PERMIT

SEWAGE DISPOSAL SYSTEM

HOWARD COUNTY HEALTH DEPARTMENT

REVISED
 SITE PLAN
 CAMPBELL'S CORNER
 LOT 1

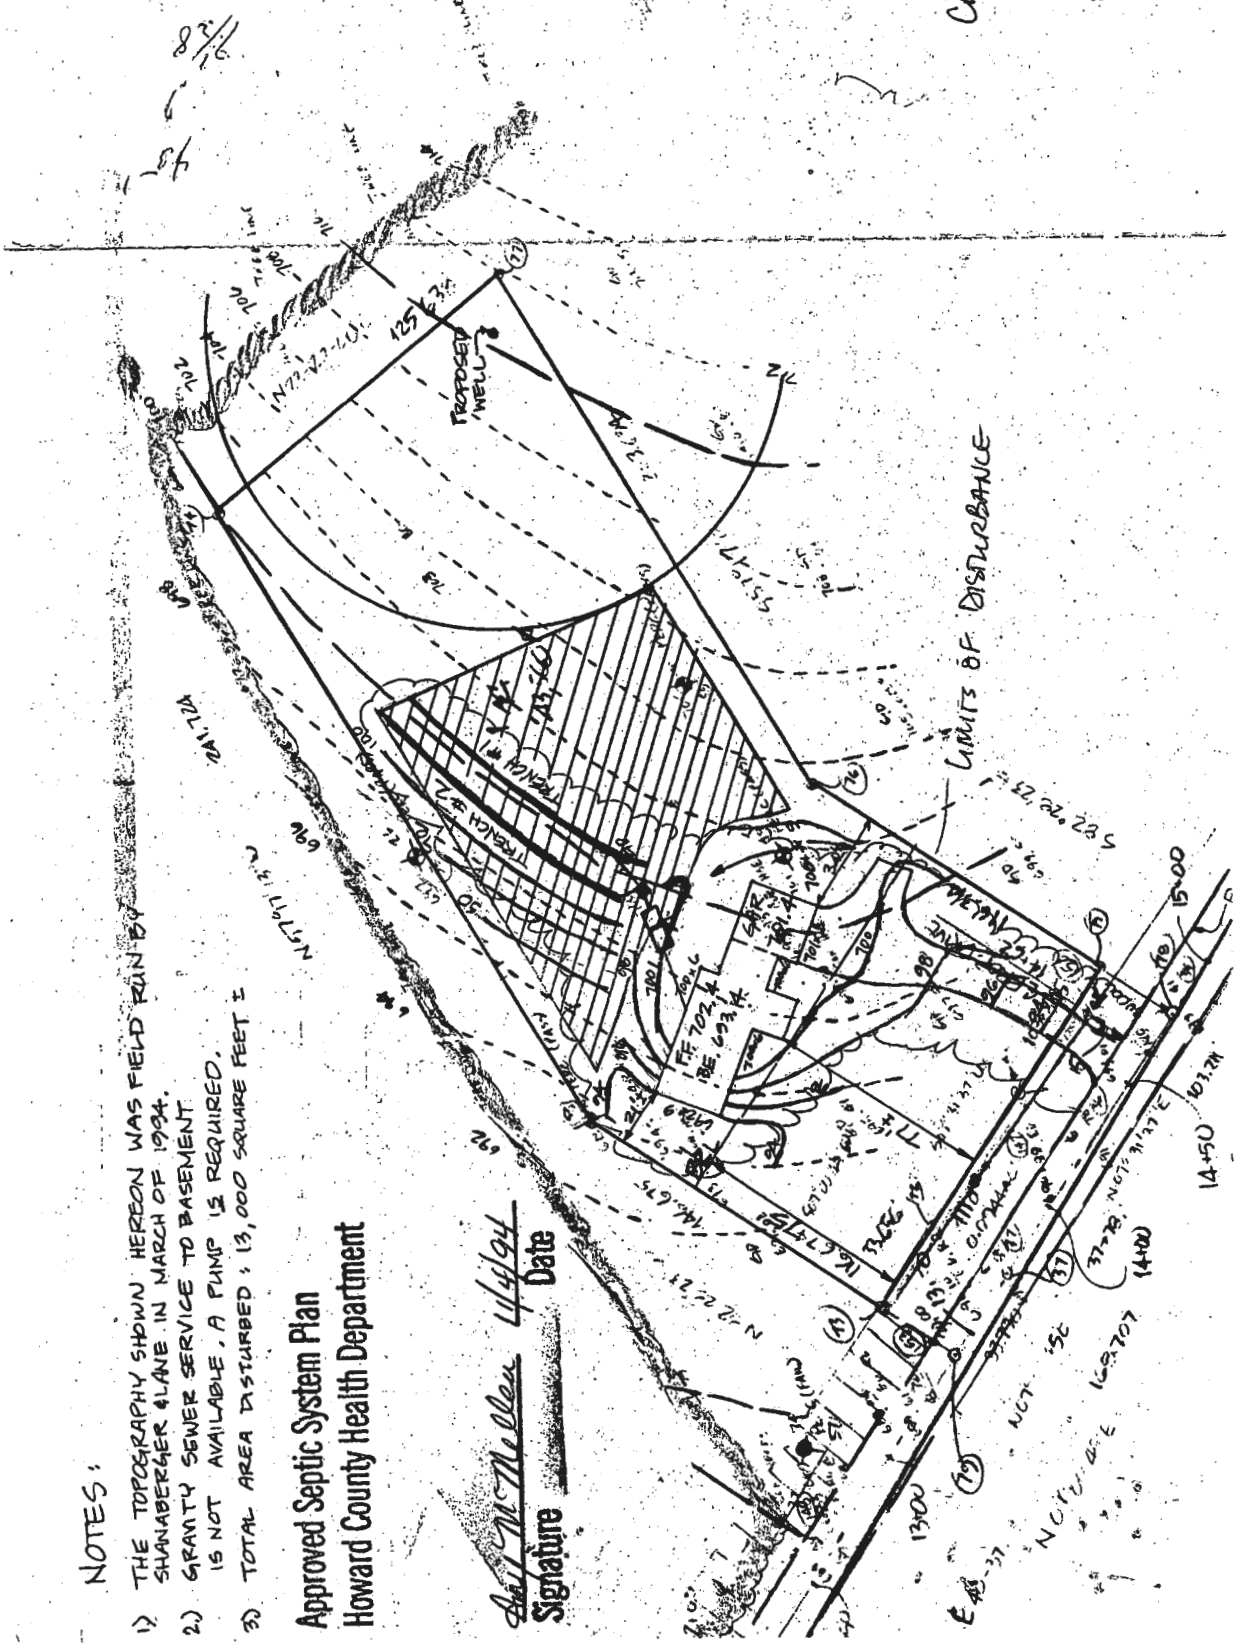
Note Trenches of septic system going into hill away from home

PLANS APPROVED BY Amy McMillen + Ckd. at site 3/20/95 DATE 11/04/94

REVISED
SITE PLAN
CAMPBELL'S CORNER
LOT 1

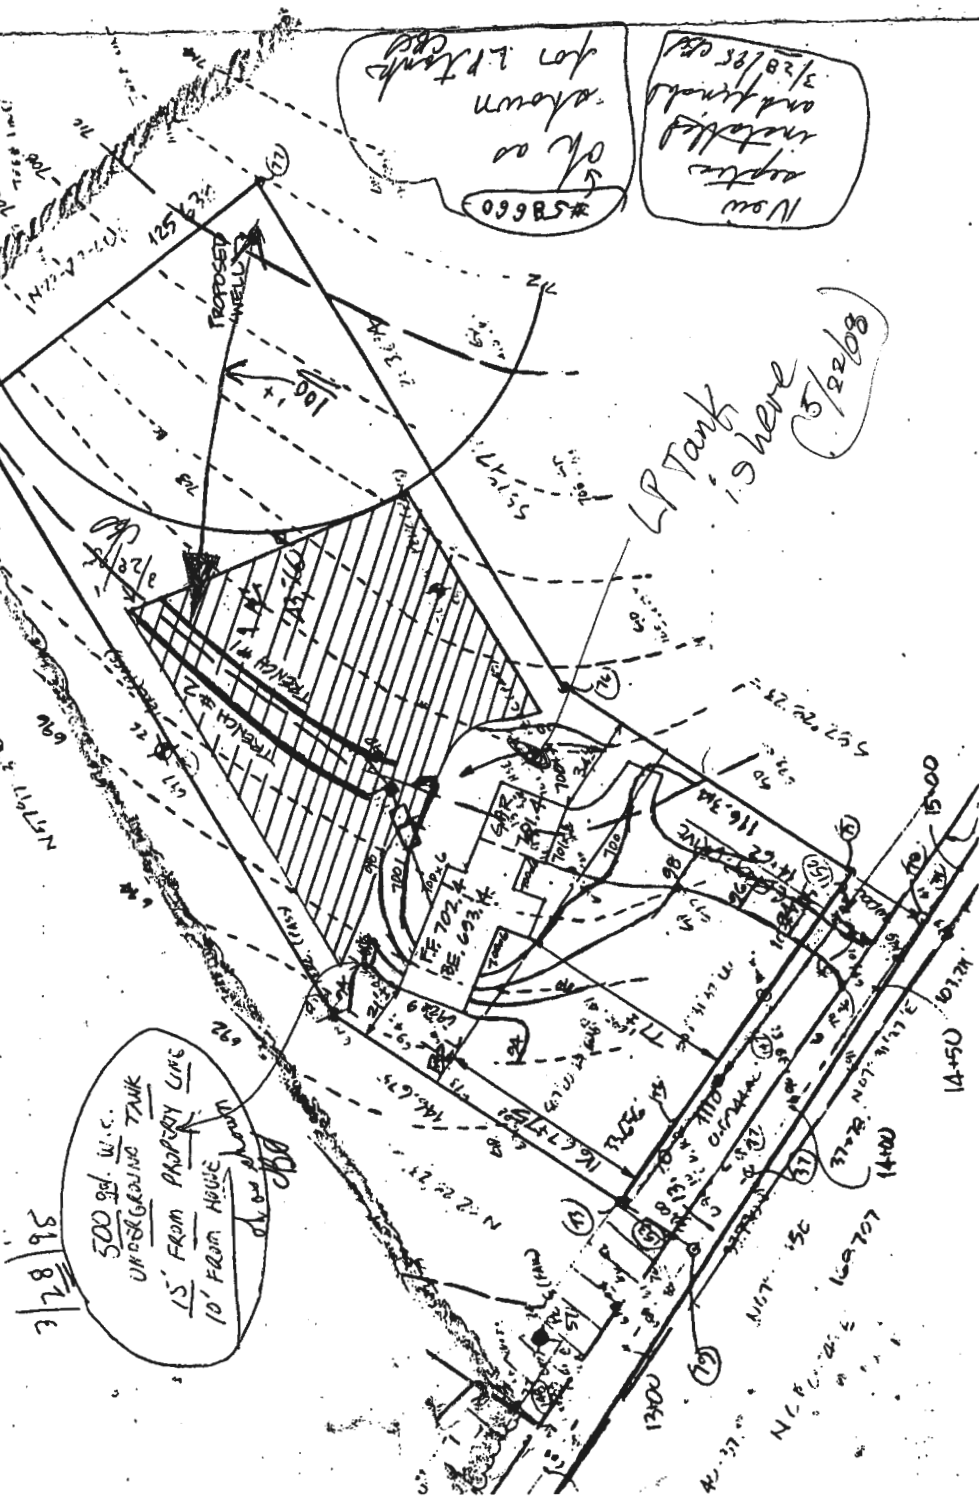
Handwritten notes in circles:
 - "09985#"
 - "New meter installed and kind shown for LP tank"
 - "3/28/85"

Handwritten note:
 "LP Tank is here (5/22/08)"

Handwritten note in a circle:
 "500 gal. U.C. UNDERGROUND TANK 15' FROM PROPERTY LINE 10' FROM HOUSE"
